# DA RFI Response

Project No: **63367**  
 Project Name: **The Family Place**  
 Address: **35A & 35B North Road Woodridge QLD 4114**  
 Council: **Logan City Council**  
 Application No. **MCUI/41/2024**  
 Date: **11/09/2024**

Figure 4 - Proposed Fence line Change

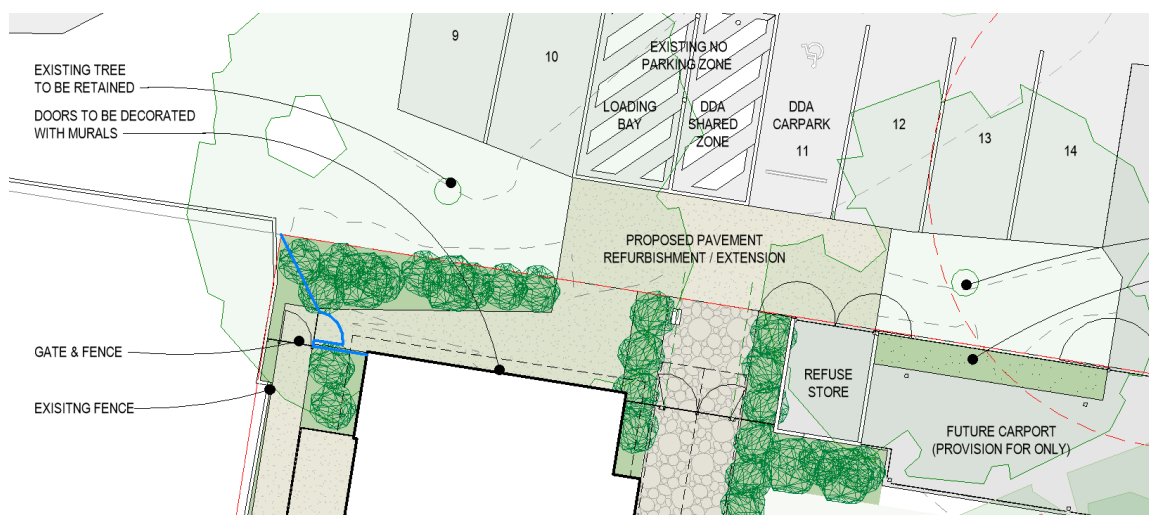
**2.6.2** - Demonstrate how the proposal defines the common boundary and prevents encroachment of existing and future uses into public open space, and alternatively prevents the public encroaching onto the site after-hours.

Advice Note: Based on the plans provided, it appears the frontage of the site contains landscaping in an area that is not secured by any fencing and does not define the site boundary from the park boundary. There is concern that this area may be considered public space after hours considering the proximity to the parkland. Please consider moving the proposed fencing and entrance gate to the boundary extent or provide additional details (character / design) of additional similar fencing to secure the boundary.

In order to eliminate the small blind spot between site and the neighbouring fence we are proposing altering the decorative fence line and gate for the staff access as per the blue line in figure 4 below.
